C12.1	N0444/14 - 213 Whale Beach Road Whale Beach - Demolition of existing dwelling and construction of new single dwelling, garage and pool
--------------	---

**SUBJECT: N0444/14 - 213 Whale Beach Road, Whale Beach NSW 2107
- Demolition of existing dwelling and construction of new
single dwelling, garage and pool**

SUBJECT: N0444/14 - 213 WHALE BEACH ROAD, WHALE BEACH NSW 2107 demolition of existing dwelling and construction of new single dwelling, garage and pool

Figure 1: Existing ground levels relative to the development now proposed.

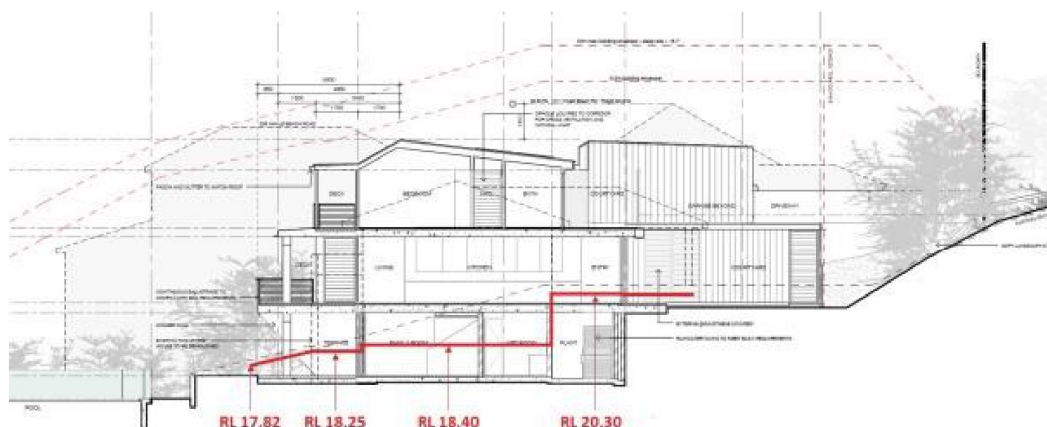
The LEP specifies that building height is to be measured from existing ground level (and not from natural ground level, as was the case with the previous set of planning controls). In this case, an existing dwelling house exists on the site, much of which is located lower than the surrounding ground level; the submitted survey plans show that the existing covered parking area at the front of the property is located at RL 20.30, and that the lower of the two levels of the existing dwelling is located at RL 18.40. The proposed replacement dwelling is located largely within the same footprint as this existing dwelling, and is not as wide as this existing dwelling, meaning that the relevant existing ground levels can be easily understood. The proposed dwelling extends approximately 2.4 metres further to the rear than the existing dwelling however, and so the grassed ground level of RL 17.82 has been taken as the relevant existing ground level for the assessment of this section of the building. Figure 1 below demonstrates the existing ground levels relative to the development now proposed:

The uppermost ridge of the new dwelling is noted as RL 26.85, which is 8.45 metres above the RL 18.40 ground level of the existing dwelling at this point. The frontmost part of the proposed dwelling, comprising the garage also has an uppermost RL of 26.85 which is 6.55 metres above the RL 20.30 of the ground level below. The rearmost portion of the dwelling steps down to two storeys and measures 5.34 metres above the grassed rear slope. Each of the building elements are within the maximum control of 8.5 metres and as such the development complies with the numerical requirements of this control.

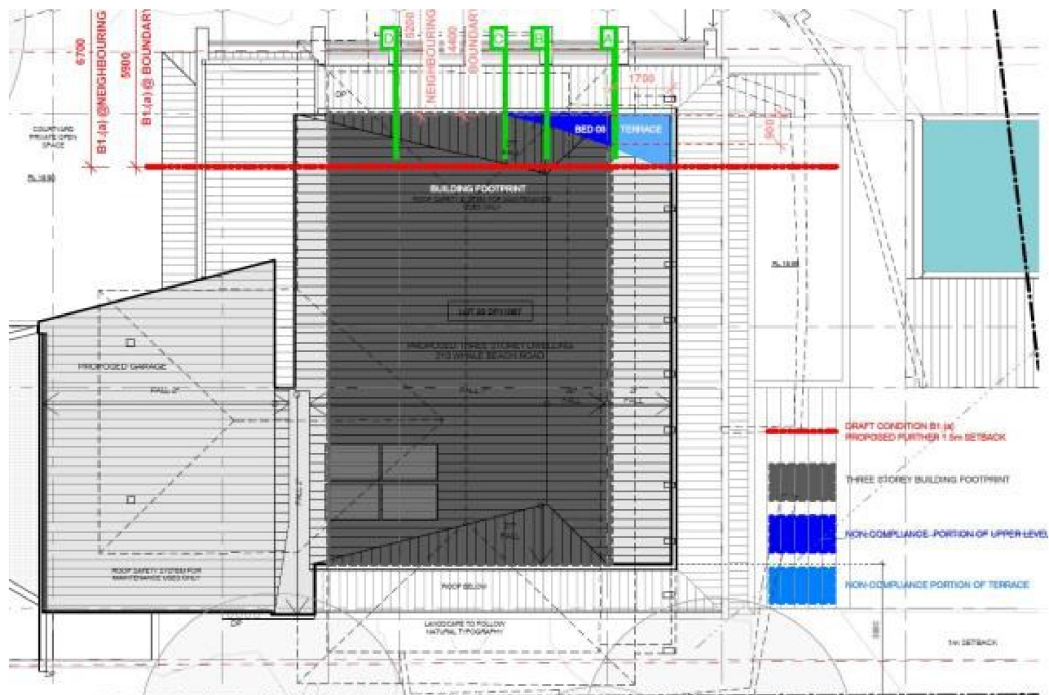
On the southern side, the non-compliances relate to the eaves of the uppermost level and (further toward the front) a section of open timber framing above a bathroom. This timber framing does not appear to serve a structural purpose given that the bathroom below includes a flat roof and the area does not appear to serve as a walkway. A condition has been included to delete this element, with a view to reducing this non-compliance and the amount of perceived bulk.

To the north, the non-compliance relates to a more substantial portion of the upper level, including approximately half of the northernmost bedroom and an associated section of roof and eaves. The variations to the control permit assessment on a merit basis where the building footprint is situated on a slope over 16.7 degrees (i.e. 30%). While the applicant asserts that the slope of the land exceeds this, it has been established that the portion of land below the building footprint (i.e. not including any other parts of the site) is closer to 10 degrees and so does not qualify for this variation.

The outcomes of the control require new development to achieve the desired future character of the area and to minimise bulk and scale, as well as preserving views. Objections have been received from neighbouring properties to the proposed exceedence of this control specifically due to the impact of this on views. The protrudance of this part of the upper level outside of the building envelope will contribute to the view loss experienced by the properties on the western side of Whale Beach Road. While this view loss has been identified as minimal, it does not follow that a more skilful design should not be sought to preserve as much of this view as possible. This is a large dwelling, and the reduction in the extent of this upper floor will not render the house unduly small or result in the removal of an unreasonable amount of floorspace.

For this reason, a condition is recommended for the northern wall of this upper level to be set further back from the northern boundary by at least 1.5 metres, and the interior layout adjusted to suit. Such a setback would eliminate the non-compliance other than the outermost part of the eaves, which is considered acceptable.
